**WARRANTY  
 BULLETIN**

Wb00-05

| <b>SUBJECT :</b> CLEARANCE BETWEEN FAN AND RADIATOR |                  |                     |

FIGURE 1 : FAN DRIVE ASSEMBLY COMPONENTS : (1) STOP; (2) DRIVING BELTS  
IN INSET : REAR ENGINE STARTER SELECTOR SWITCH AND BELT TENSIONERS PRESSURE RELEASE VALVE

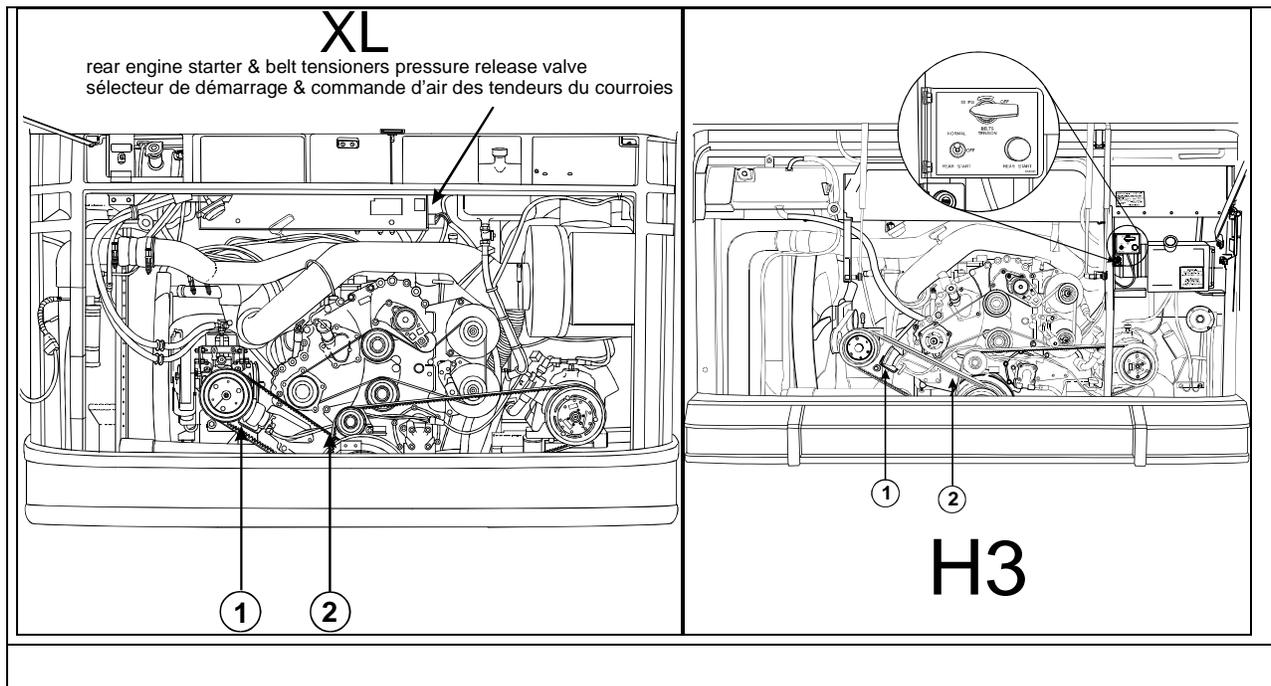
1. Open engine compartment rear door.
2. Set the rear engine starter selector switch to the "OFF" position (figure 1).
3. Rotate the fan and check if there is friction between the fan and any parts of the radiator.

4. Using a portable lamp, make a visual inspection to check if there are any wear marks.
5. Remove the air pressure from the belt tensioners (figure 1) and remove the 3 driving belts.

6. Rotate the fan drive assembly counterclockwise in order to have it resting against the stop at its extreme position (figure 1).
7. Repeat the verification of step 3.

8. If there are no wear marks, no modification is necessary on your vehicles. Reinstall the 3 driving belts, apply the air pressure to the belt tensioners, set the rear engine starter selector switch to "NORMAL". The verification is now completed.

9. If there are wear marks on the parts, it is necessary to proceed with part B of this bulletin.

FIGURE 2 : FAN DRIVE ASSEMBLY

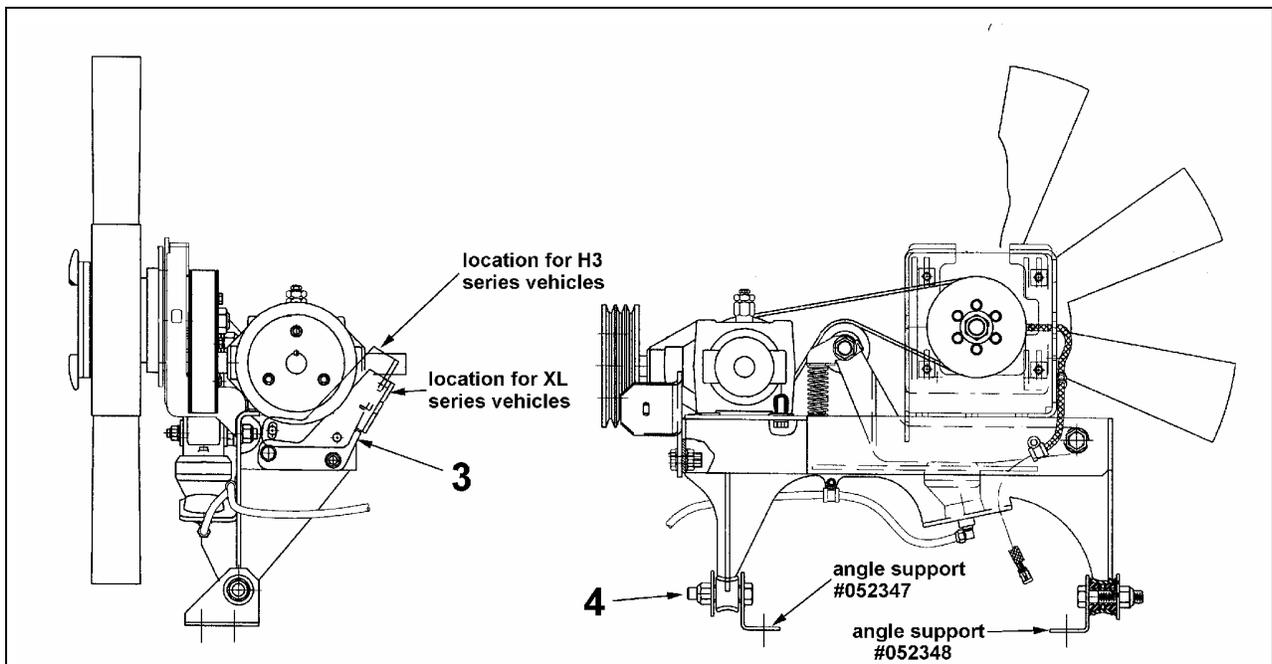
On the above mentioned vehicles, it is necessary to check the clearance between the fan and the radiator. If the clearance is not sufficient and there is friction between those components, a modification has to be performed.

5. Remove the tensioner arm (figure 2 item 3). Take note of its position.
6. Proceeding with one side at a time, unscrew the pivot bolt (4) at the base of the fan drive assembly (figure 2).
7. Remove the actual angle support and replace by a new one (figure 2).
8. Reinstall and tighten the pivot bolt (4).
9. Repeat step 3,4 and 5 for the other side.
10. Install the new tensioner arm (3) to its proper position according to the type of vehicle (figure 2).
11. Install the 3 new driving belts.
12. Apply the air pressure to the belt tensioners, set the rear engine starter selector switch to "NORMAL".  
The modification is now completed.
